Subject: 30000300A – Vessel Charter – Capelin spring acoustic survey NL

ADDENDUM #1

Addendum (#1) is hereby issued to advise potential bidders of questions and answers for this tender call and modify the mandatory evaluation criteria.

Drawing of transducer mounting plate and transducer heights/sizes. Note bottom plate is constructed of 1/2 inch steel with rings welded on to allow for transducer attachment.

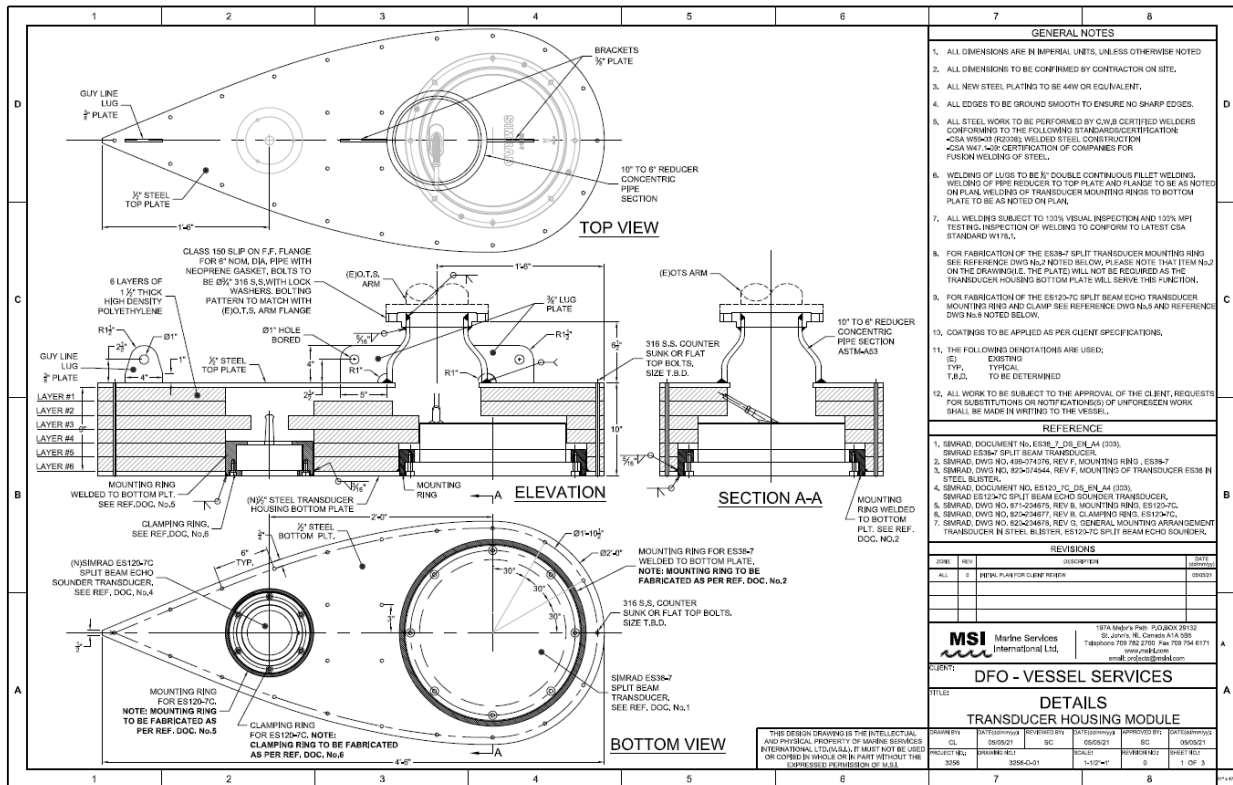
Q3 When/Where will transducer mounting equipment be made available?

A3: The plate on which transducers will be mounted in currently being fabricated and will be ready by May 28 or 29. You will be responsible with fitting this plate with sides so that it can be mounted to the underside of your fin. Note that transducer housing extends above the plate so the sides on the plate will need to be 10” high. Drawing for the plate is on the following page. Note this drawing was initially designed for a different application,

the top and middle sections will not be used in this application, only the bottom plate with transducers fitted in. Unlike the drawing the base plate will not have bolt holes pre-drilled.
